Model	Service Bulletin Description	Number
All	Water softeners O-rings Tygon tubing Back flow prevention Contactors SSM water filter parts Serial Number Format Change Ice machine sanitation after a boil order Color and Model Series Change	PS-6-88 PS-9-88 PS-2-89 PS-9-92 PS-1-98 PS-8-98 PS-8-2004 PS-7-2005 PS-6-2006
AC125	Water inlet valve New leg parts	PS-1-89 PS-7-97
AF300	New oil seal New water shed New motor and motor housing	PS-12-2002 PS-15-2003 PS-1-2005
AFE325	New oil seal New water shed New motor and motor housing New compressor	PS-12-2002 PS-15-2003 PS-1-2005 PS-5-2005
AFE400	Drain and water system parts Bin thermostat bracket change TXV change New oil seal New water shed New motor and motor housing New compressor Added hi pressure cut out	PS-11-97 PS-4-2000 PS-13-01 PS-12-2002 PS-15-2003 PS-1-2005 PS-5-2005 PS-1-2006
Bins	Door frames Gasket color change BH260 and BH375 parts BH360 bin SB480 bin BH1100, BH1300, BH1600 bin Ice Express Service Parts Ice Express Cart Service Parts BH801 Service Parts BH1100, 1300, 1600 changes	PS-2-2000 PS-4-2000 PS-14-2000 PS-8-2002 PS-4-2003 PS-6-2003 PS-2-2004 PS-3-2004 PS-10-2004 PS-5-2006

SERVICE BULLETIN

Subject: Wiring Diagram Change, FME2404R and NME1854R

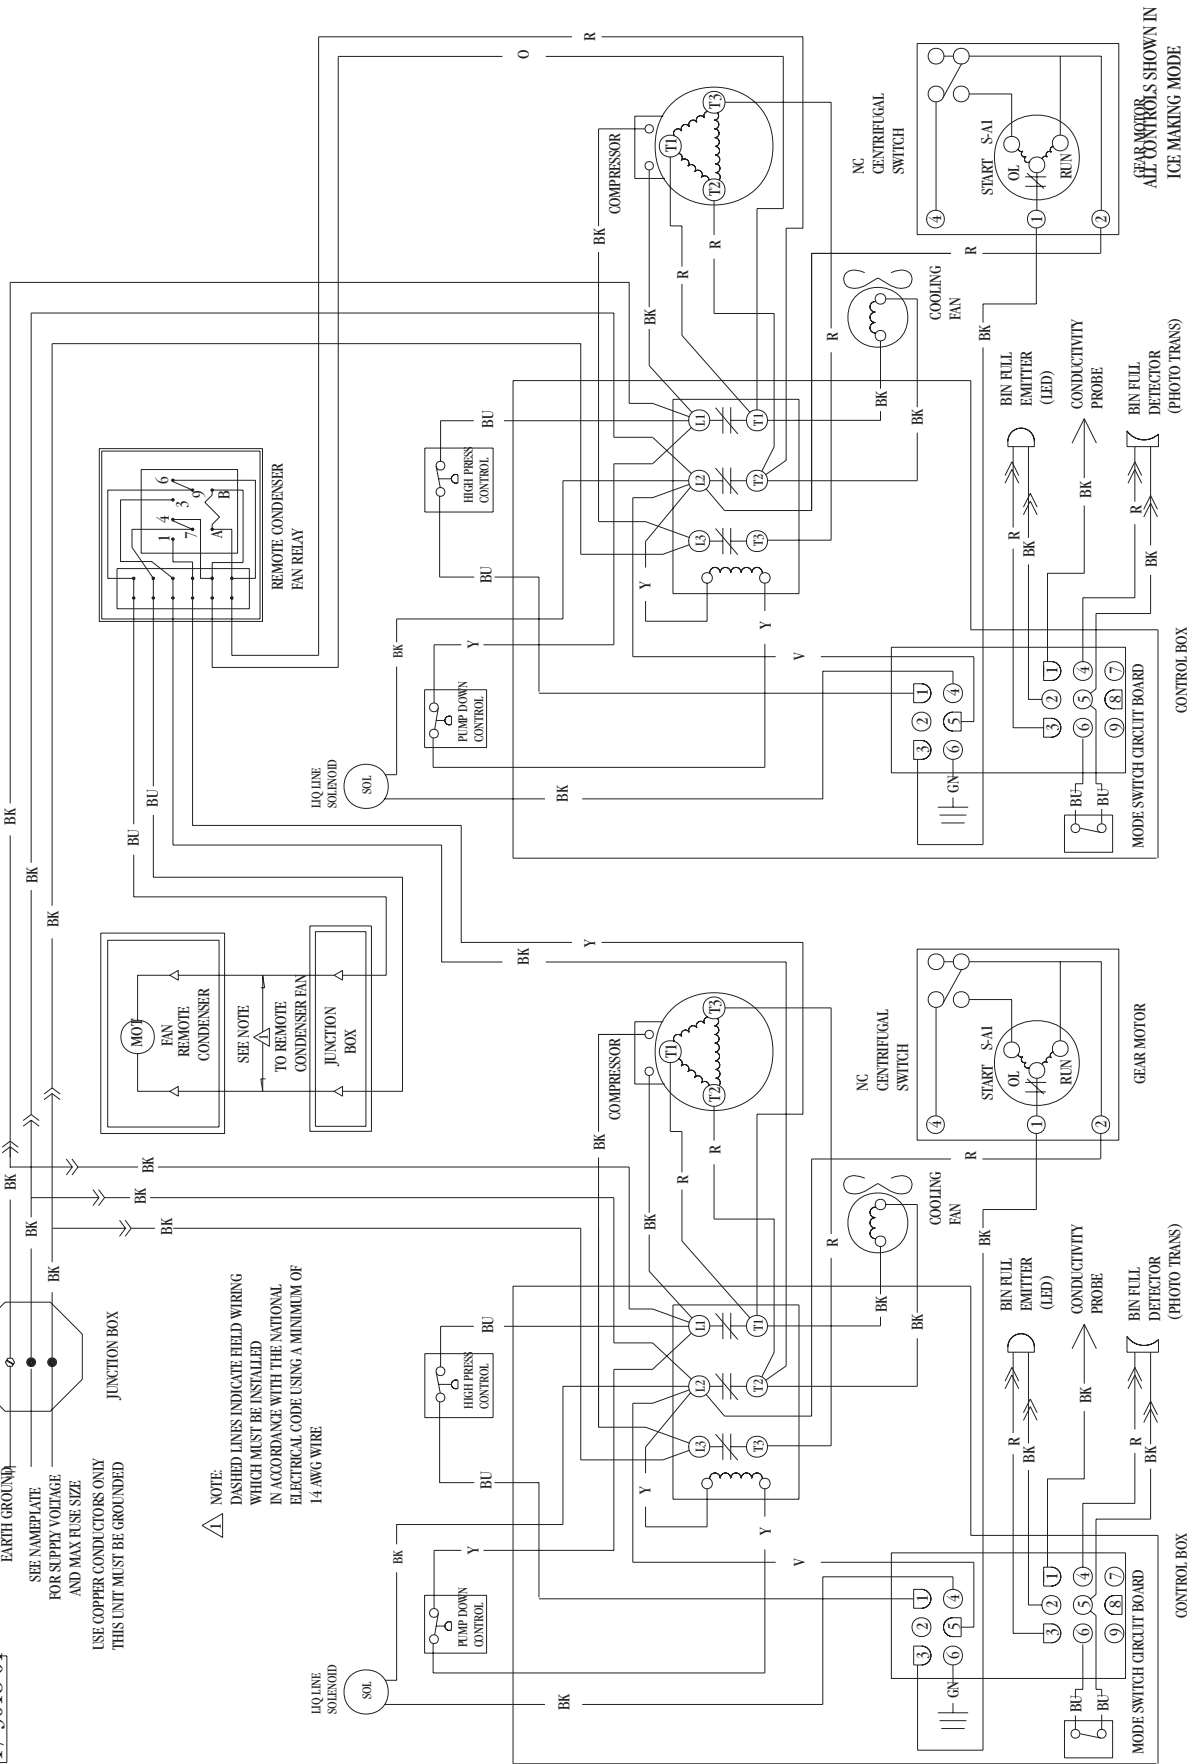
The wiring diagram for these models has been changed to correct an error. The original diagram wiring resulted in a mis-phased fan relay, which caused early life failure of the relay contacts. The single phase diagram is shown here, the three phase diagram is on the back of this bulletin.

Subject: MDT2 Front Panel Drain Change

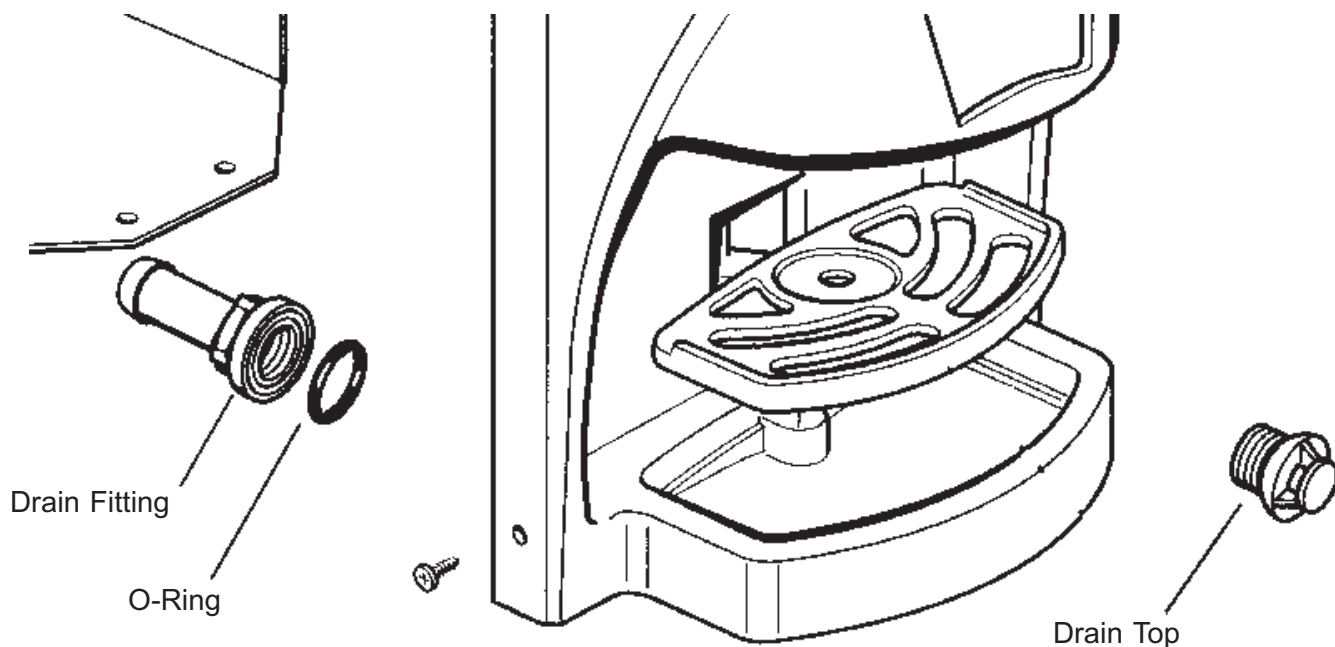
Beginning with serial number 707393-04S, the drain portion of the front panel has been changed. The prior drain was a PVC tube glued to the front panel. The new design uses a screwed together assembly, as shown in the exploded diagram below.

Note: To remove a front panel on the new design, the drain top must be removed so the panel can be separated from the drain fitting.

Subject: CME2006 and CME1856 mounting grommet change

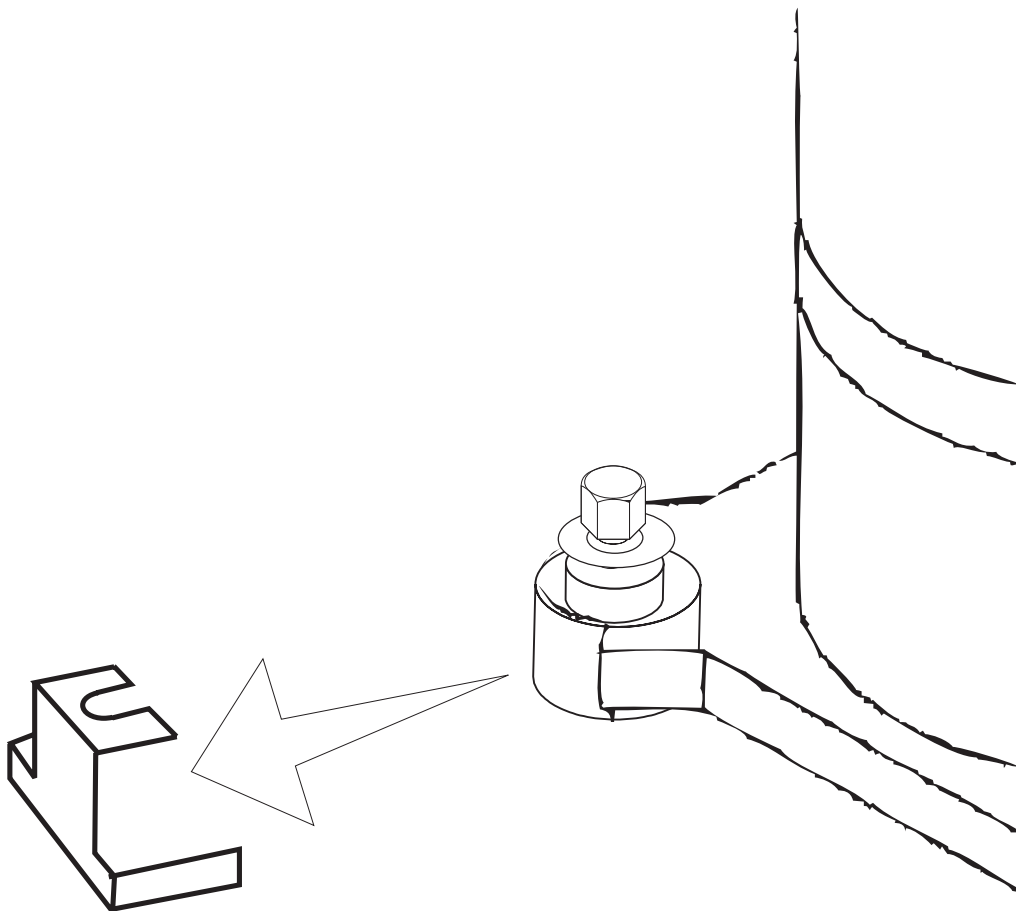
The new grommet part number is: 03-3843-01. Related parts include: 03-1407-07, flat washer and 18-2300-26 sleeve.

Due to the softer nature of the new grommets, shipping brackets have been incorporated under the back two compressor mounts. These shipping brackets must be removed at start up.

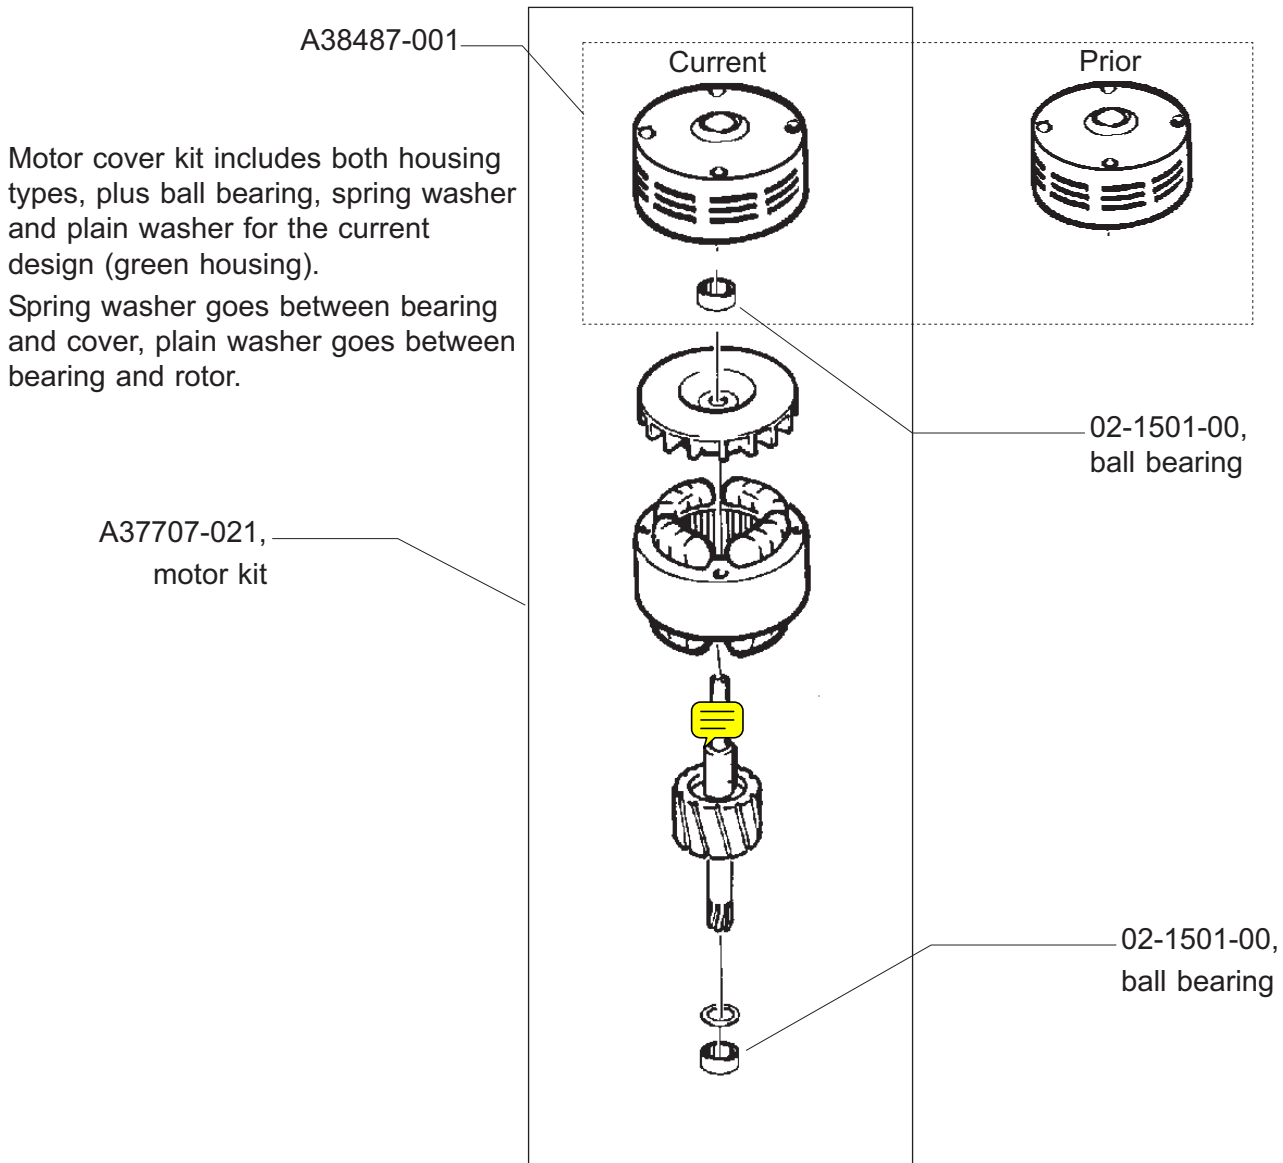
The auger drive motor for the 1/10 HP gear reducer has been changed. The motor now has ball bearings at both ends. Production of AFE400s & AFE325s with this change began in late September. One service part is affected. The prior motor's sleeve bearing was supplied as part of the motor housing. A new motor housing kit that includes both the prior motor housing (BLUE) and the new motor's housing (GREEN) is now available. Both include new bearings. The kit number is: **A38487-001**.

Both of the new motor's bearings are part number 02-1501-00.

Subject: High Pressure Cut Out added to AFE400 air cooled.

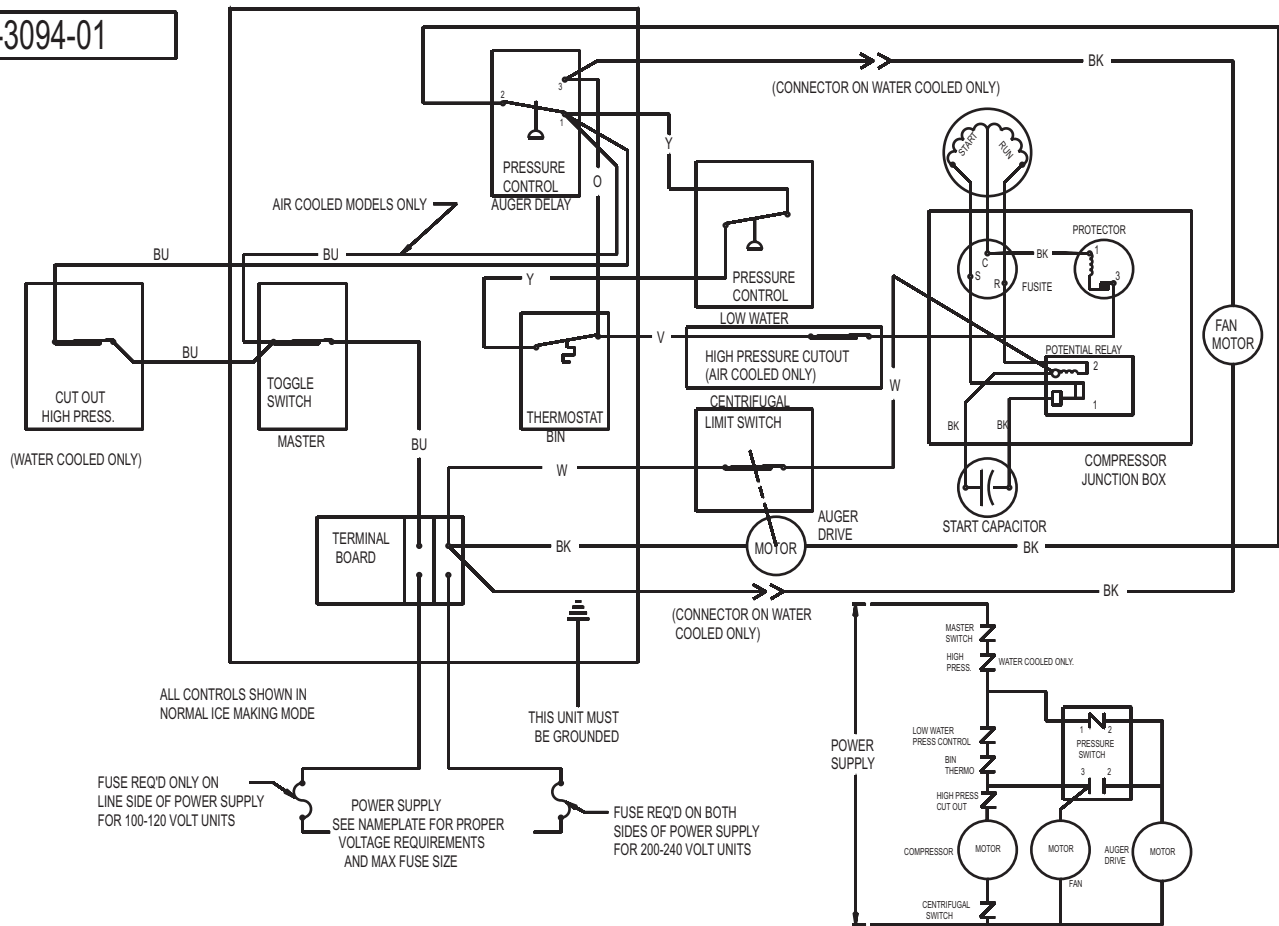
A high pressure cut out switch has been added to the air cooled AFE400. The service part number is 11-0501-24. If the discharge pressure exceeds the cut out pressure setting, the switch will open and shut off the compressor. The switch will automatically reset when the pressure falls to the cut in pressure.

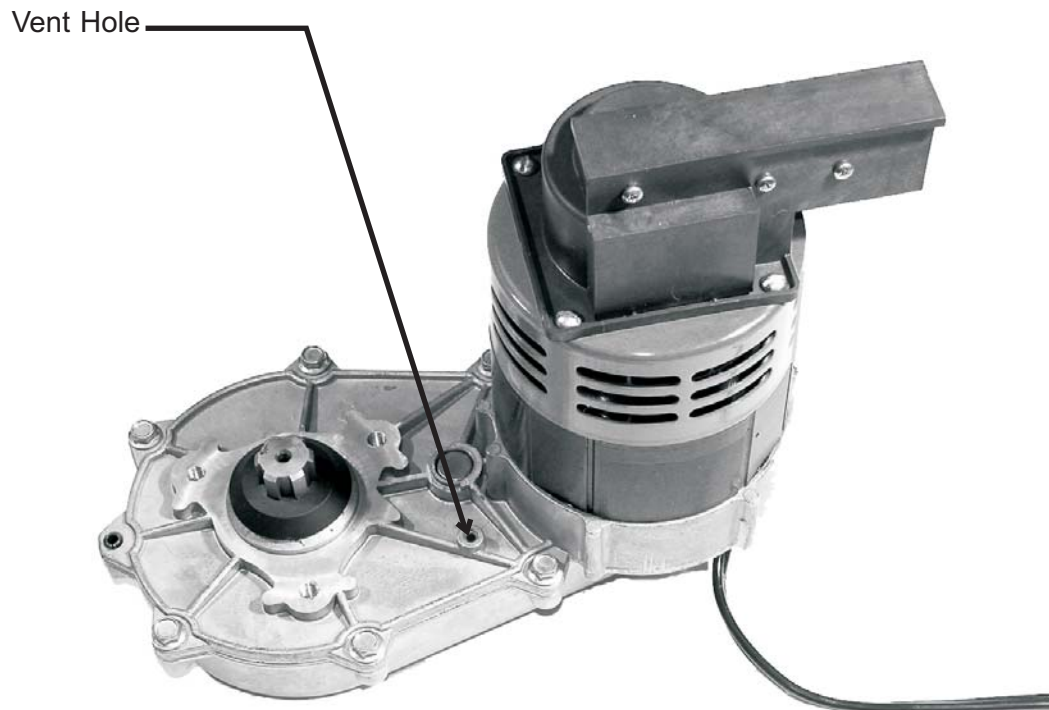
The vent holes in the covers of all 1/10 HP gear reducers have been determined to be unnecessary and are being eliminated. This includes gear reducers in ice machines, complete gear reducers and individual service parts.

It is no longer necessary to remove the shipping vent plugs from any of these gear reducers.
